Product Change Notification PCN

PCN-2022-008

Subject: Change of packaging and packaging unit (PU)

Description of the packing rail

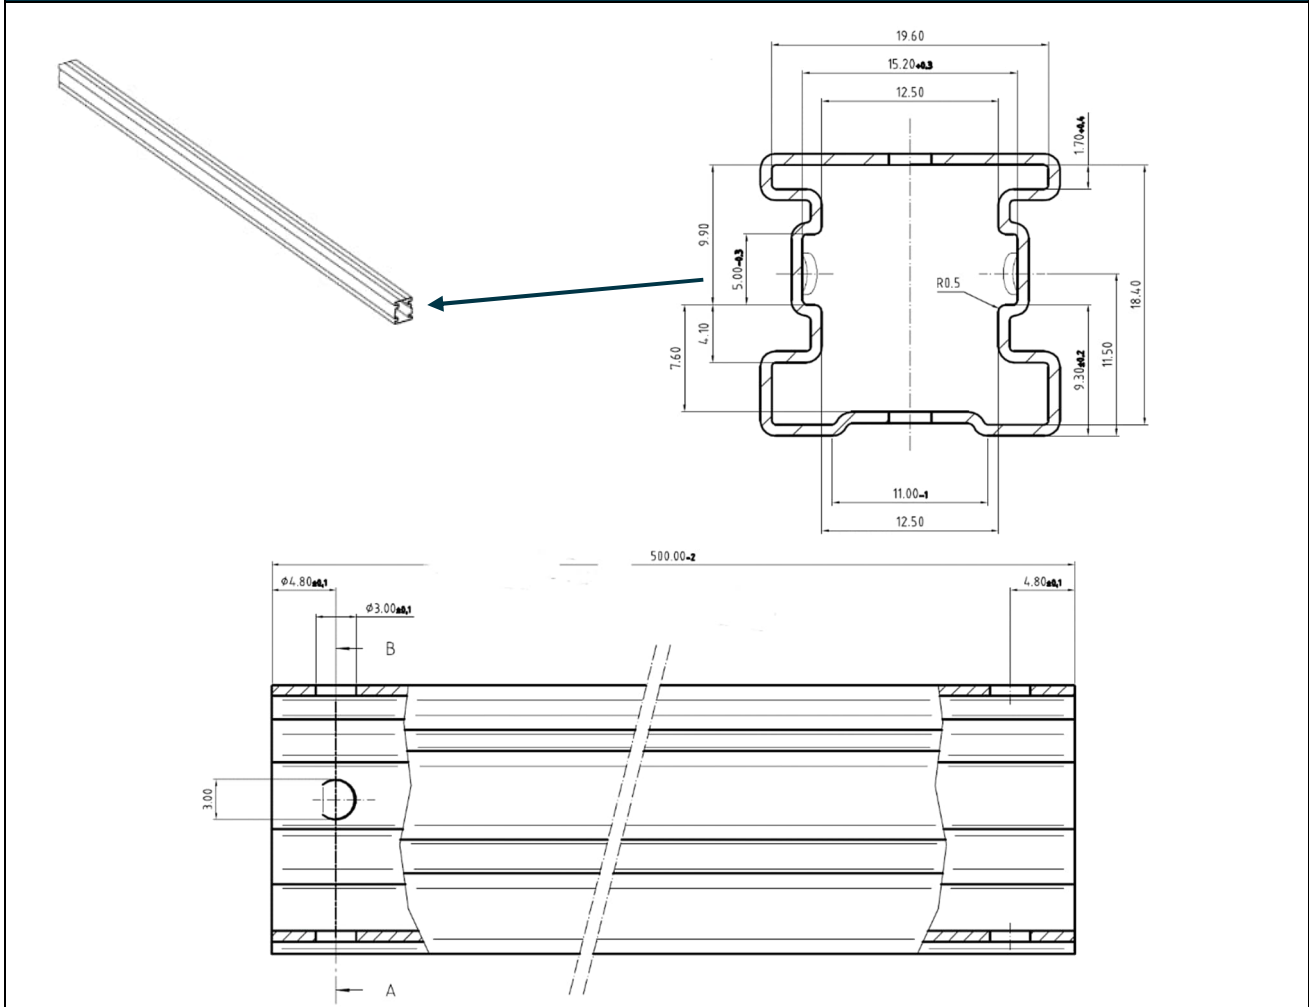
Article number	Description	Category of change	Description of change	Launch date
3.14.100.601/0000	RF 15 N Tactile switch Au	<input type="checkbox"/> dimensional <input type="checkbox"/> appearance <input type="checkbox"/> materials <input type="checkbox"/> functional <input checked="" type="checkbox"/> other	The packaging changes from a carton to a packaging rail. This will adjust the PU from 25 pcs to 32 pcs. This is just a packaging change.	From April 28, 2022

3.14.100.606/0000	RF 15 N Tactile switch Ag	<input type="checkbox"/> dimensional <input type="checkbox"/> appearance <input type="checkbox"/> materials <input type="checkbox"/> functional <input checked="" type="checkbox"/> other	The packaging changes from a carton to a packaging rail. This will adjust the PU from 25 pcs to 32 pcs. This is just a packaging change.	From April 28, 2022

3.14.100.801/0000	RF 15 R Tactile switch Au high	<input type="checkbox"/> dimensional <input type="checkbox"/> appearance <input type="checkbox"/> materials <input type="checkbox"/> functional <input checked="" type="checkbox"/> other	The packaging changes from a carton to a packaging rail. This will adjust the PU from 25 pcs to 32 pcs. This is just a packaging change.	From April 28, 2022

3.14.100.806/0000	RF 15 R Tactile switch Ag high	<input type="checkbox"/> dimensional <input type="checkbox"/> appearance <input type="checkbox"/> materials <input type="checkbox"/> functional <input checked="" type="checkbox"/> other	The packaging changes from a carton to a packaging rail. This will adjust the PU from 25 pcs to 32 pcs. This is just a packaging change.	From April 28, 2022
